Quality Assurance Program Description for the APR1400 Design Certification

APR1400-K-Q-TR-11005-NP-A
Revision 1

SUBJECT: ADVANCED POWER REACTOR 1400 FINAL TOPICAL REPORT SAFETY
EVALUATION, TOPICAL REPORT APR1400-K-Q-TR-11005-NP, REVISION 4,
"KHNP QUALITY ASSURANCE PROGRAM DESCRIPTION FOR THE APR1400
DESIGN CERTIFICATION"

SAFETY EVALUATION FOR TOPICAL REPORT APR1400-K-Q-TR-11005-NP, REVISIONS 4, “KHNP QUALITY ASSURANCE PROGRAM DESCRIPTION (QAPD) FOR THE APR1400 DESIGN CERTIFICATION” (RQ4804)

Figure II. 1-1 KHNP APR1400 DC Project Organization

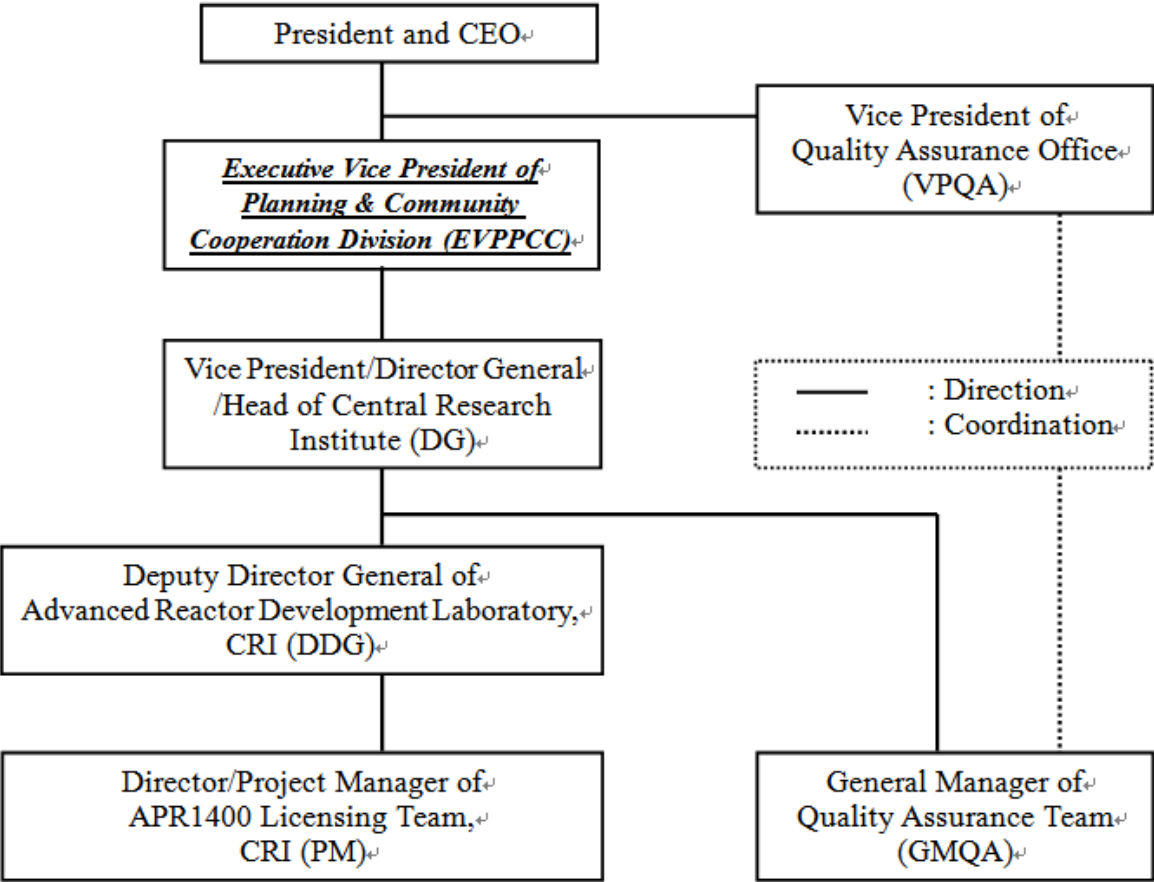
The Director General (DG) of KHNP Central Research Institute (CRI) to direct the Deputy Director General of Advanced Reactor Development Laboratory (DDG) in addition to the current duties and requires the Director of APR1400 Licensing Team reports to KHNP's DG and the DDG.

The Executive Vice President's title changed from "Safety & Technology Division (EVPSTD)" to "Planning & Community Cooperation Division (EVPPCC)."

The above changes were included in TR APR1400-K-Q-TR-11005-NP, Revision 4. The NRC staff determined that these minor organization changes are not reductions in commitment from TR APR1400-K-Q-TR-11005-NP, Revision 2 (ADAMS Accession No. ML13238A025), previously accepted by the NRC; and therefore are acceptable.
